# ADDENDUM NO. 05 – PORTAGE PUBLIC SCHOOLS – CENTRAL ELEMENTARY SCHOOL BP 4: CONSTRUCTION

# ADDENDUM NO. 5 (BP4)

PROJECT: Central Elementary School Bid Package 4: Construction

ARCHITECT'S PROJECT NO.: 21-237.10

CHOOL

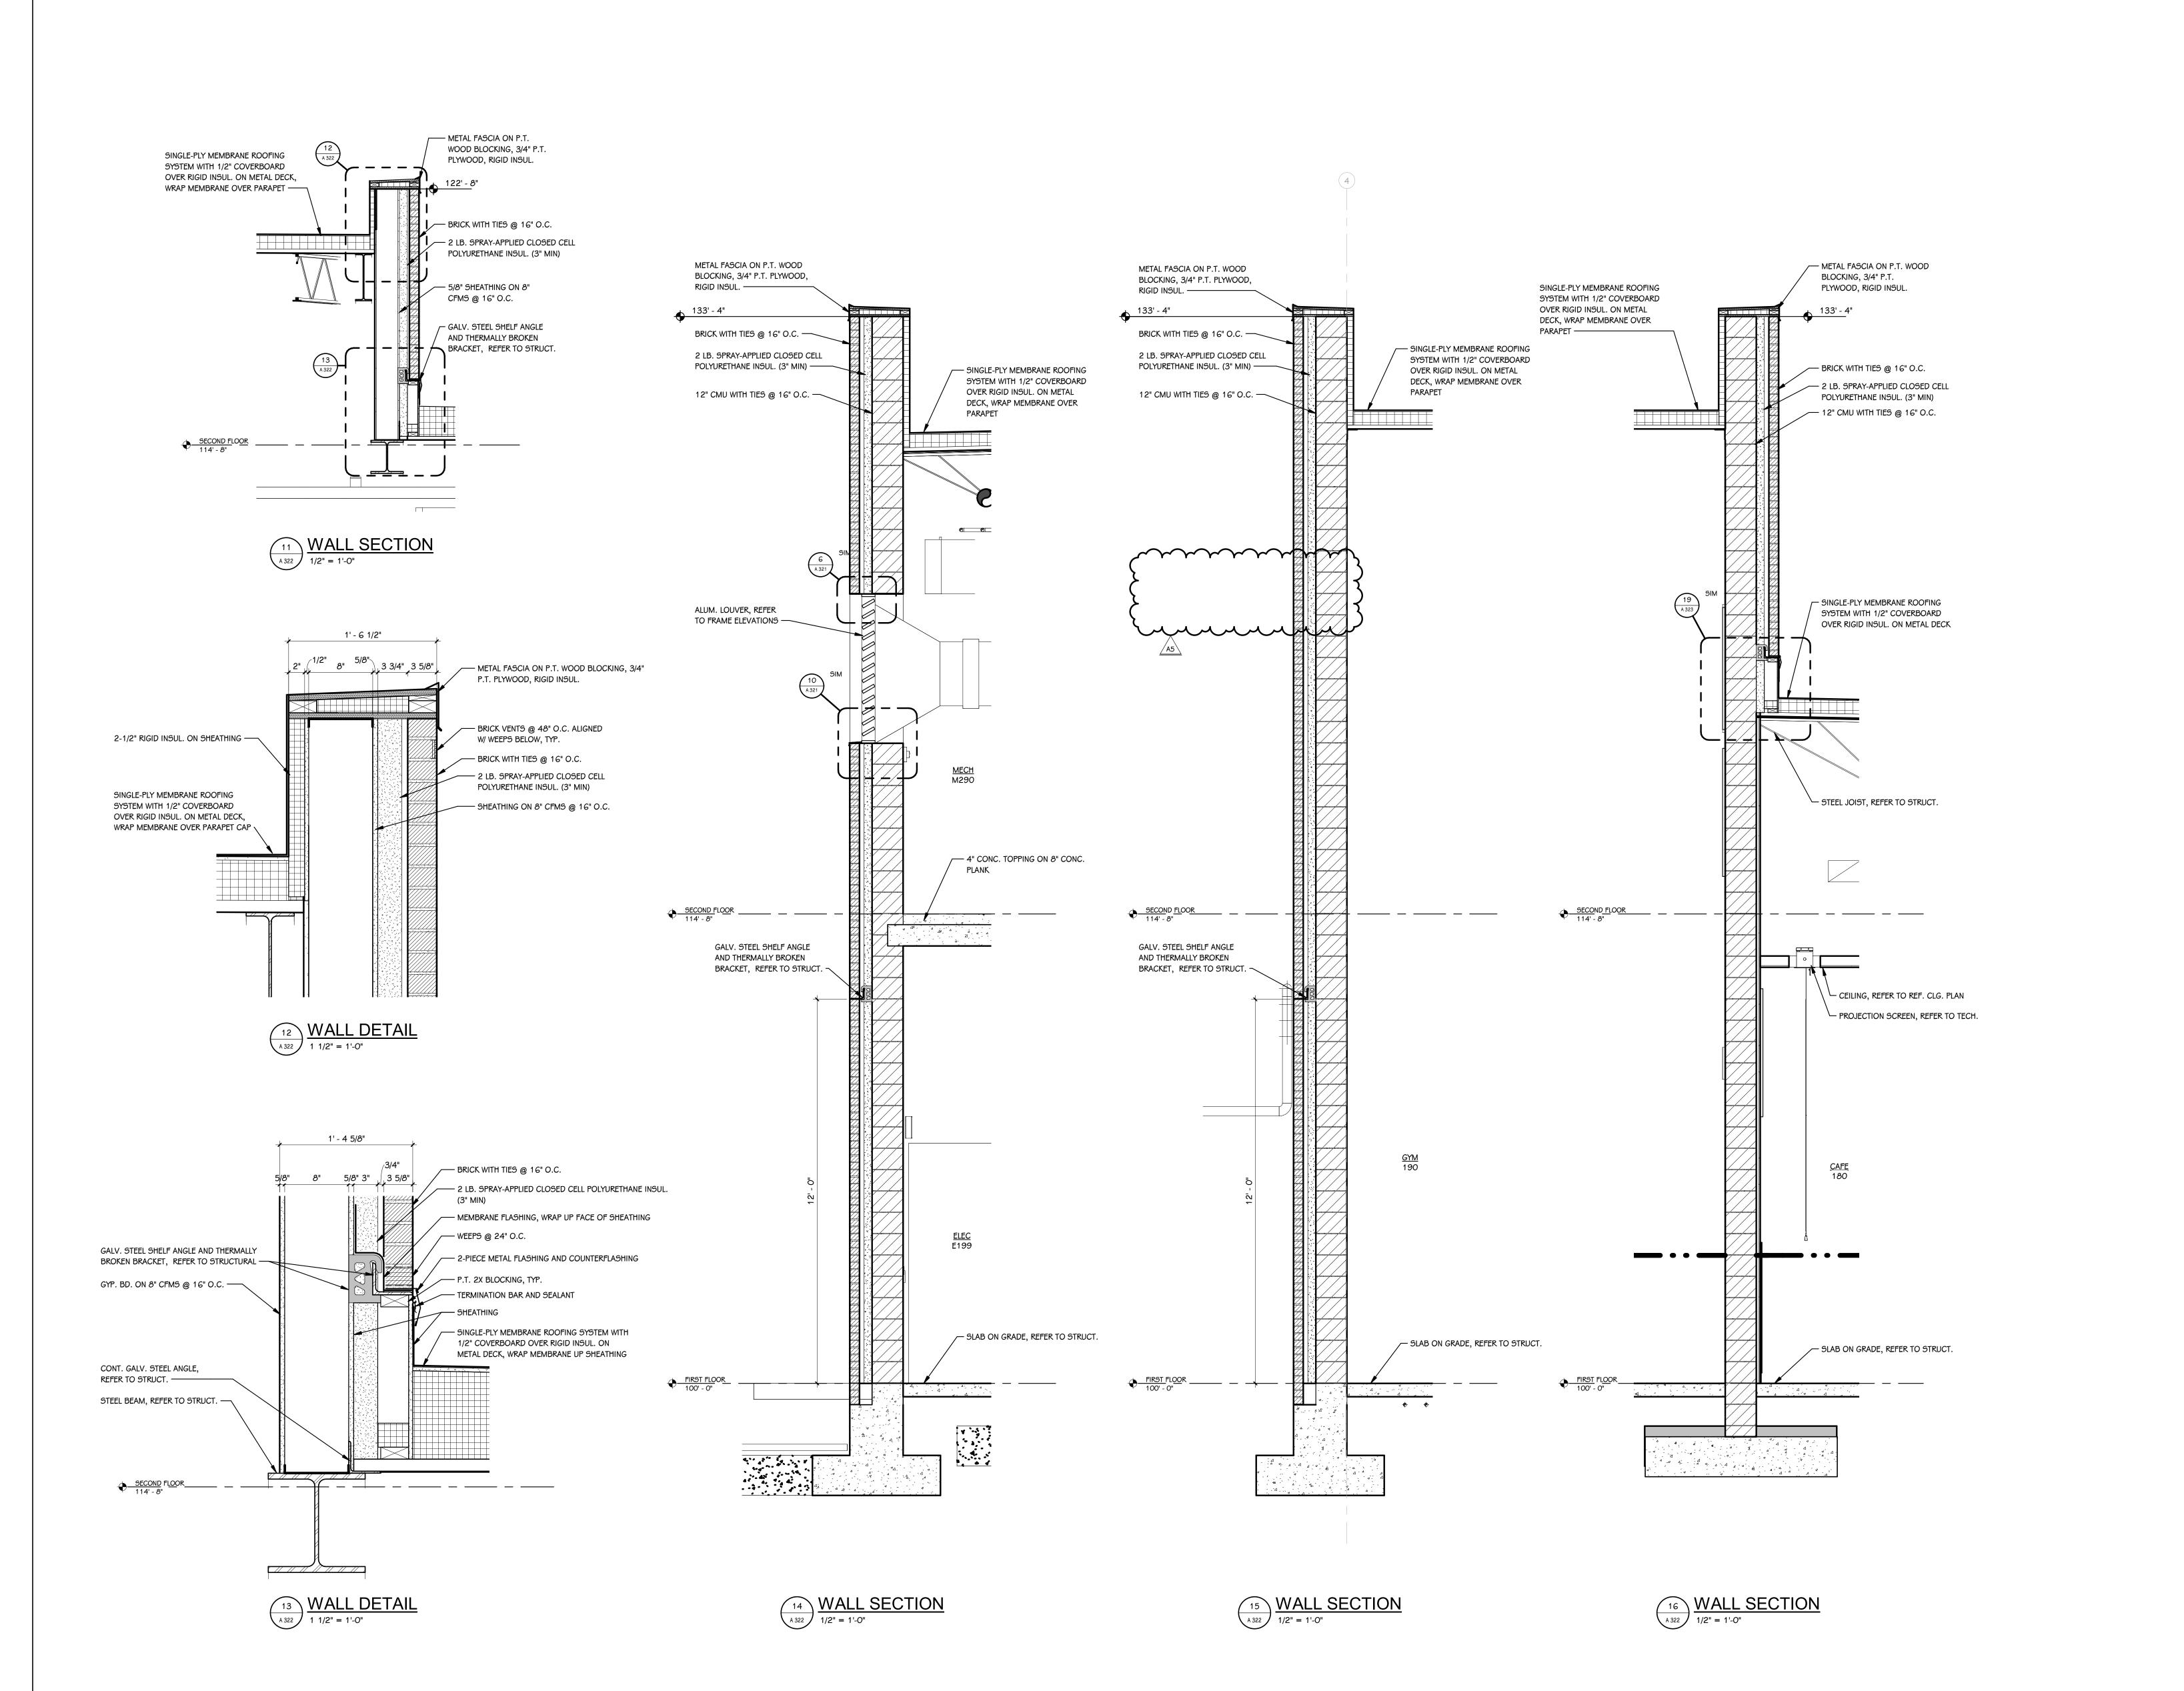
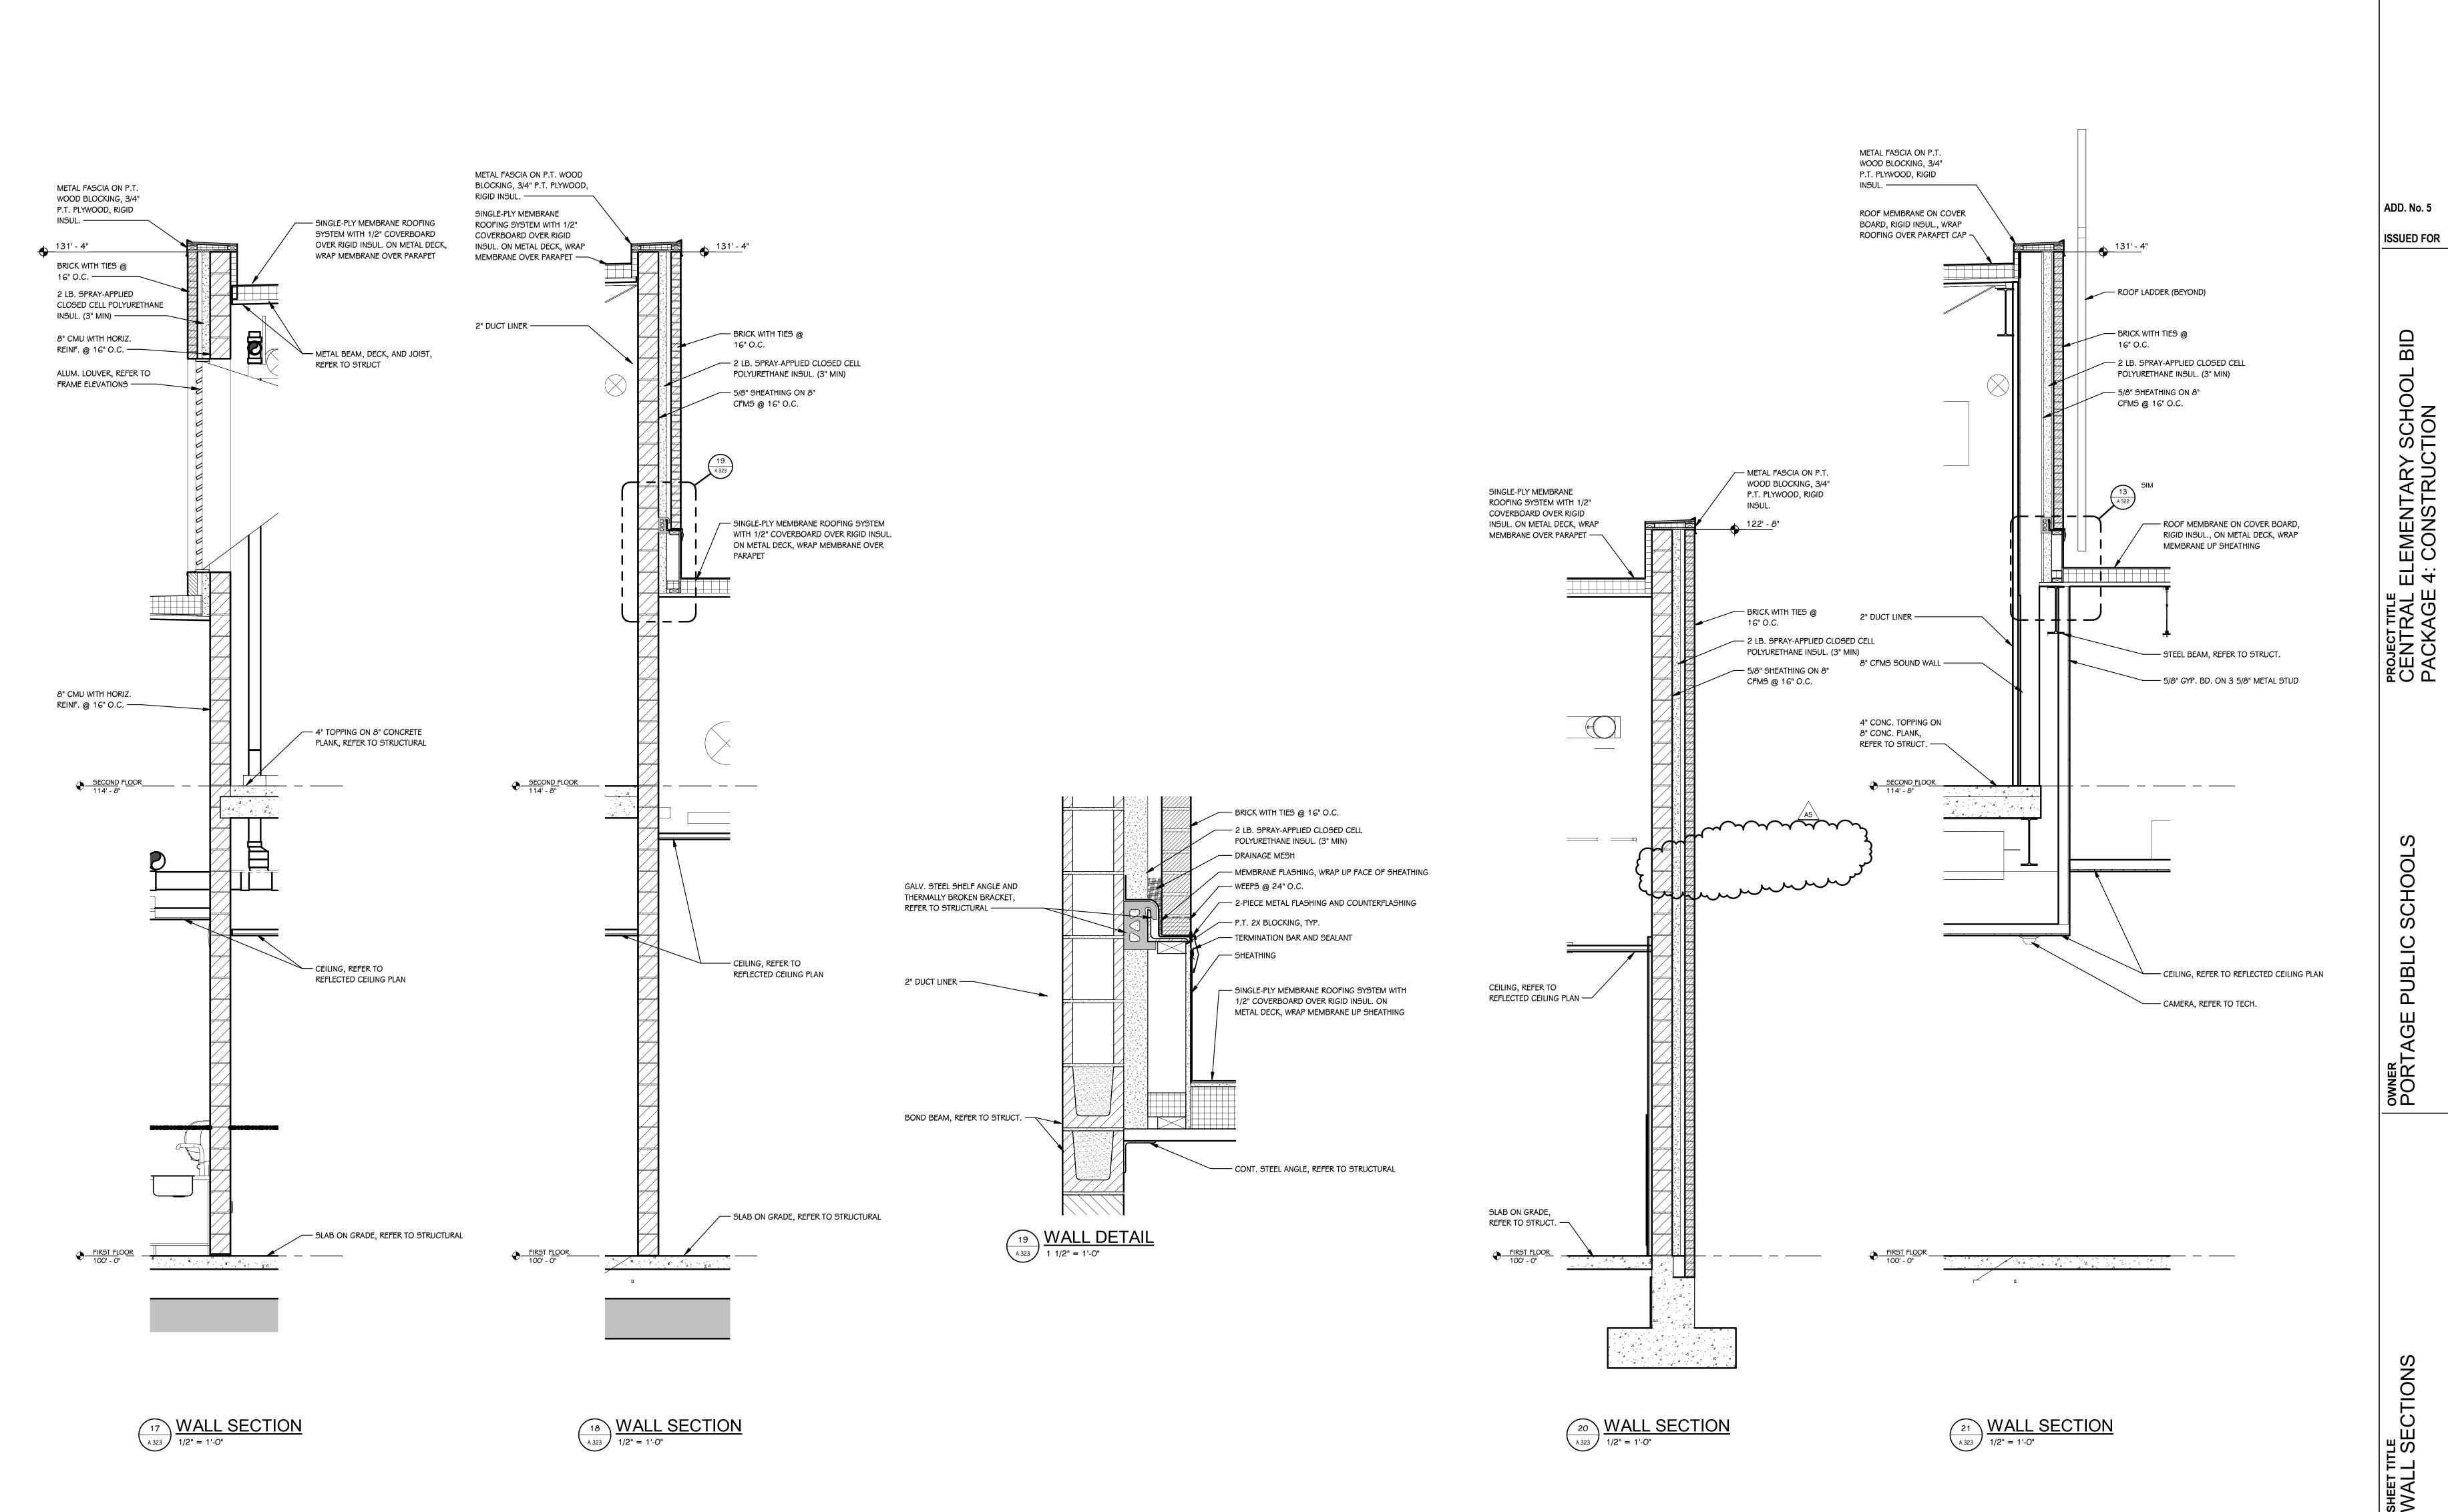
#### ADD-5 Item No. D-7 - Thermal Brackets at Veneer Bearing

Fero Fast thermal bracket detail updated. Thickness of continuous shelf angle is revised.

Revised wall sections to remove shelf angle and bracket in alignment with 2<sup>nd</sup> floor openings. Revised shelf angle and bracket note, added typical note to 1/A321, provide membrane flashing, cavity drainage mesh, weeps and vents at shelf angle [12'-0"h locations].
